Groundwater Application Review Summary Form

Application # G- <u>18871</u>	
GW Reviewer Karl Wozniak	Date Review Completed: November 21, 2019
Summary of GW Availability and Injury Review:	
Groundwater for the proposed use is either of amounts requested without injury to prior water capacity of the groundwater resource per Section	
Summary of Potential for Substantial Interferen	nce Review:
There is the potential for substantial interfere	ence per Section C of the attached review form.
Summary of Well Construction Assessment:	
[] The well does not appear to meet current we review form. Route through Well Construction a	ell construction standards per Section D of the attached and Compliance Section.
This is only a summary. Documentation is attach	ned and should be read thoroughly to understand the may be necessary for a permit (if one is issued).

Application G-18871 Date: November 21, 2019

Well Statistics, Sections 31 (4S/4W) and 36 (4S/5W)

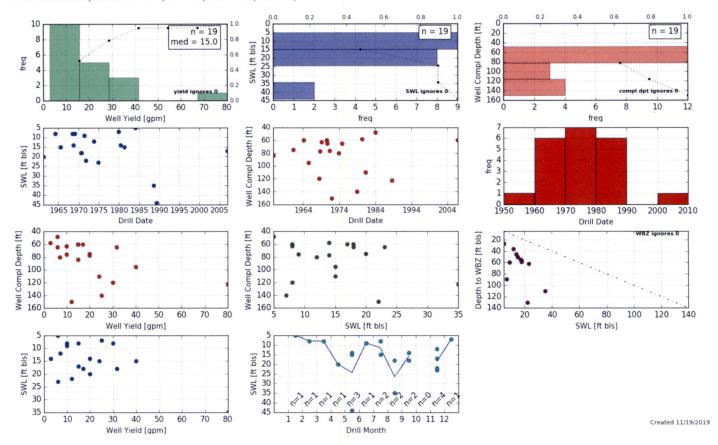
Well yields in section 31, T4S/4W and section 36, T4S/5W range from 3-80 gpm with a median yield of 15 gpm (see enclosed graphs). About half of the yields were determined by the air test method which tends to overestimate the final yield of a completed well; the remainder were determined by bailer or pump tests which showed moderate to excessive drawdowns relative to the total depth of the wells. All of the wells in the dataset (19) are domestic wells, most of which have 6-inch diameter casing. The application indicates that the proposed irrigation wells will have 10-inch diameter casings which should, all else being equal, allow somewhat higher yields. However, because of the limited thickness of the aquifer, it is highly unlikely that the total requested rate of 1.78 cfs (800 gpm) can be realized from the 4 proposed wells. These factors strongly indicate that the groundwater for the proposed use will not likely be available within the capacity of the resource at the requested rates. This finding can be mitigated by reducing the maximum proposed rate to 0.141 cfs (63 gpm) which is just

Water-Level Trends in Nearby Wells

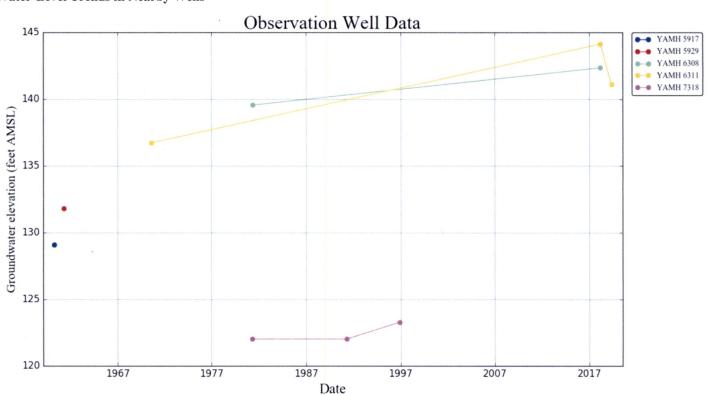
Groundwater-level measurements are sparse in the area (see included plot) but current levels are expected to be stable because of the low density of irrigation and domestic wells. However, the limited capacity of the aguifer and the proposed rates indicate that it would be prudent to require water-level and water-use measurement conditions (item B1di above) if a permit is issued by the Department.

Well Location Map

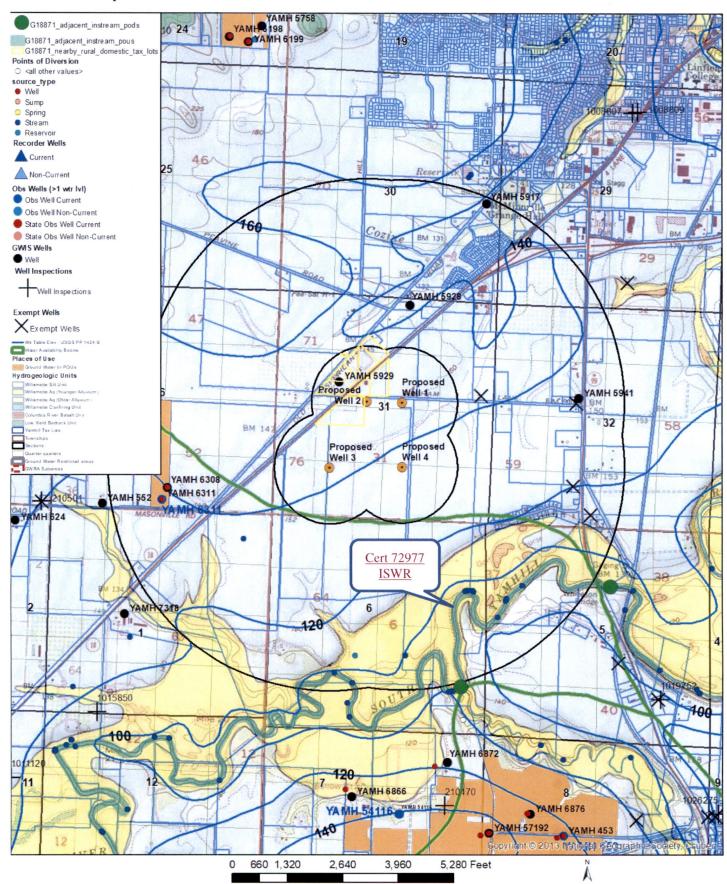
OWRD databases and tax lot maps indicate that domestic and irrigation well densities are quite low in the surrounding area. However, several rural domestic tax lots dependent upon domestic well water occur within 1/4-mile to the west and northwest of Proposed Well 2 (highlighted in yellow on enclosed map). Similarly, proposed well 2 is within about 300 feet of a house on an adjacent tax lot to the north. The precise locations of the domestic wells that serve these properties is uncertain, but the potential for substantial interference from the proposed wells, especially wells 1 and 2 – if they prove capable of yields substantially higher than median yields in the area – is high because of the following factors: the close proximity of the domestic wells; the limited thickness of the aquifer; the confinement of the aquifer (pumping impacts will spread rapidly over substantial areas); the high proposed maximum pumping rate (800 gpm); the moderate to excessive drawdowns shown on the well logs of local wells (very little water column is available to mitigate hydraulic interference – see enclosed well log YAMH 5929 as an example); the unlikely presence of deeper water-bearing zones in the alluvial aquifer system (most of the domestic wells already fully penetrate the aquifer). These factors strongly indicate that the groundwater for the proposed use will not likely be available in the amounts requested without injury to prior groundwater rights. This finding can be mitigated by reducing the maximum proposed rate to 0.141 cfs (63 gpm) and by dropping wells 1 and 2 from the application.
